DRAFT PCI-SIG ENGINEERING CHANGE NOTICE

TITLE:	PCIe Link Activation
DATE:	Introduced: 17 May 2017 Updated: 31 August 2017 Final Approval: TBD
AFFECTED DOCUMENT:	PCI Express Base Specification, Revision 4.0
SPONSOR:	Intel Corp.

Figure 7-102: L1 PM Substates Capability

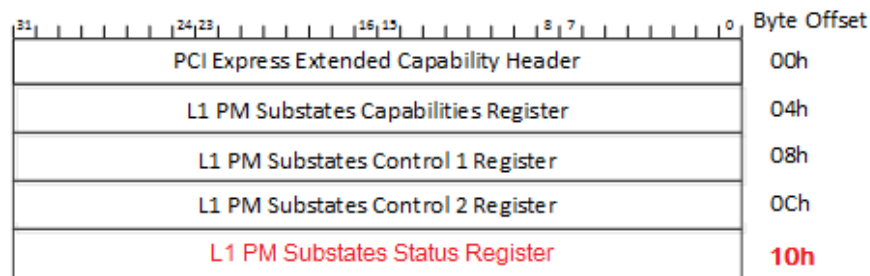
The PCI Express L1 PM Substates Capability is an optional Extended Capability, that is required if L1 PM Substates is implemented at a Port. The L1 PM Substates Extended Capability structure is defined as shown in Figure 7-102.

Location	Register Description	Attributes
...
19:16	Capability Version – This field is a PCI-SIG defined version number that indicates the version of the Capability structure present. <u>Must be 1h for this version of the specification.</u> <u>This field must be 2h if the L1 PM Substates Status Register is implemented and must be 1h otherwise.</u>	HwInit
...

Figure 7-103: L1 PM Substates Capabilities Register

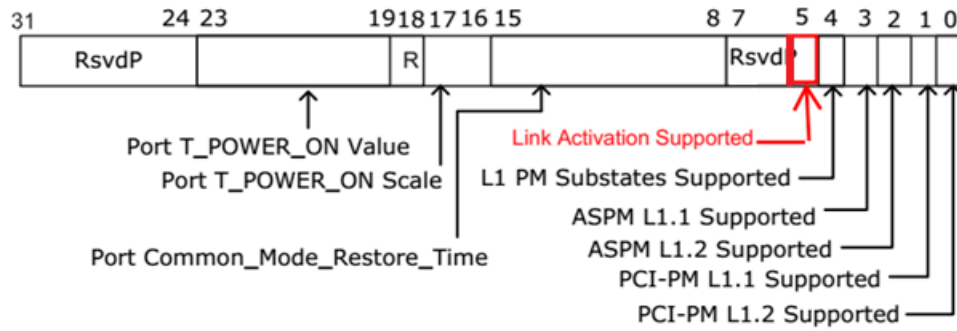
In Section 7.8.3.2, edit as shown:

Location	Register Description	Attributes
...
<u>5</u>	<u>Link Activation Supported</u> – When Set this bit indicates that this Port supports Link Activation.	<u>HwInit</u>
<u>7:6:5</u>	Reserved	RsvdP

Figure 7-104: L1 PM Substates Control 1 Register

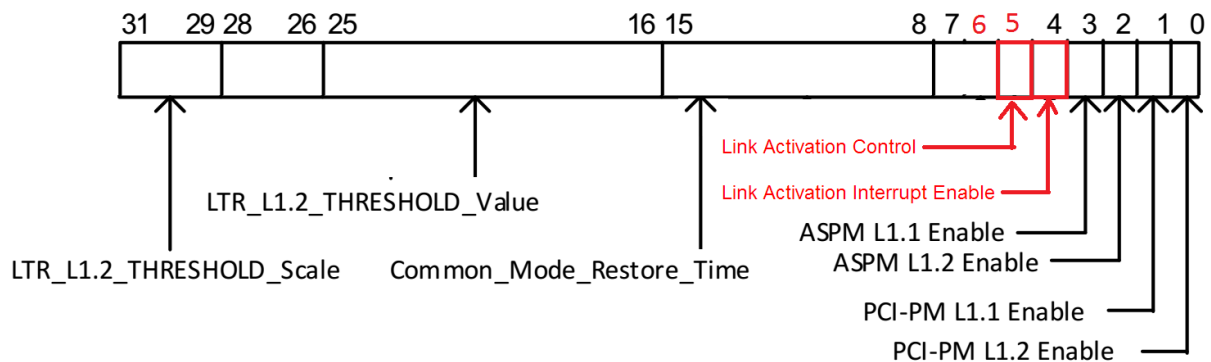
In Section 7.8.3.3, edit as shown:

Location	Register Description	Attributes
...
<u>4</u>	<p><u>Link Activation Interrupt Enable</u> – When set this bit enables the generation of an interrupt to indicate the completion of the Link Activation process. See section 5.5.6 for details.</p> <p><u>Required for Downstream Ports when the Link Activation Supported bit is Set. Must be hardwired to 0b for Upstream Ports.</u></p> <p><u>Default value is 0b.</u></p>	<u>RW/RsvdP</u>
<u>5</u>	<p><u>Link Activation Control</u> – When this bit is Set, the Port must initiate the Link Activation process. See section 5.5.6 for details</p> <p><u>Required for Downstream Ports when the Link Activation Supported bit is Set. Must be hardwired to 0b for Upstream Ports.</u></p> <p><u>Default value is 0b.</u></p>	<u>RW/RsvdP</u>
<u>7:6</u>	Reserved	RsvdP
...
